Access Compliance Report Public Rights-of-Way (Curb Ramps)

Main Street: IRVINE_BLVD Cross Street: DEAN_ST Location: SW

ADA ID: RPRK211014145323 Ramp Type: Type 4 - Parallel Initial Pass/Fail: Fail Overall Compliance: No Severity Score: 2

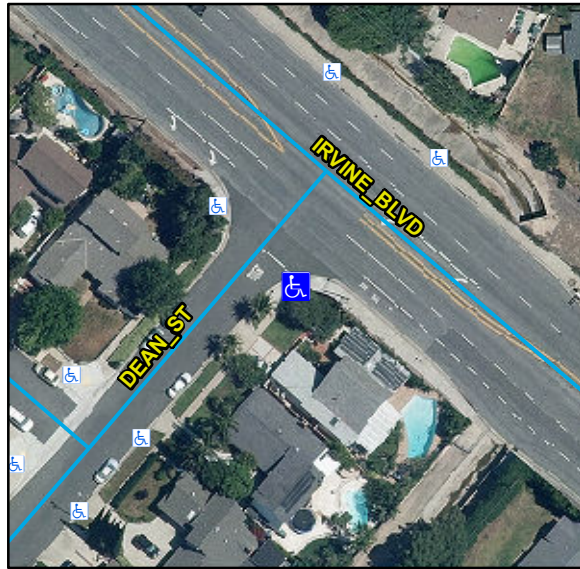
Compliance	Description	Data	Compliance	Description	Data
N/A	Ramp Length LT (in)	134	N/A	Ramp Length RT (in)	96
Yes	Ramp Width LT (in)	102	Yes	Ramp Width RT (in)	98
Yes	Ramp Run Slope LT (%)	6.4	Yes	Ramp Run Slope RT (%)	5.3
No	Ramp Cross Slope LT (%)	2.7	Yes	Ramp Cross Slope RT (%)	1.4
N/A	Landing Present	N/A	N/A	DWS Provided	N/A
N/A	Landing Length (in)	N/A	N/A	DWS Contrast	N/A
N/A	Landing Width (in)	N/A	N/A	DWS Length (in)	N/A
N/A	Landing Run Slope (%)	N/A	N/A	DWS Full Width	N/A
N/A	Landing Cross Slope (%)	N/A		DWS Offset Type	N/A
N/A	Landing Movement Obstructed?	N/A	N/A	DWS Offset Left (in)	N/A
	Landing Movement Type	N/A	N/A	DWS Offset Right (in)	N/A
N/A	Landing Shared	N/A			
N/A	Clear Space	Yes			
N/A	Clear Space To Crosswalk (in)	N/A			
N/A	Marked Crosswalk 1	No	N/A	Marked Crosswalk 2	No
	Crossing 1 Direction	NE		Crossing 2 Direction	NW
	Marked Crosswalk 1 Width (in)	N/A		Marked Crosswalk 2 Width (in)	N/A

Remove & Replace Curb Ramp With Two New Directional Ramps or Equivalent.

R304.5.3, STD 1115
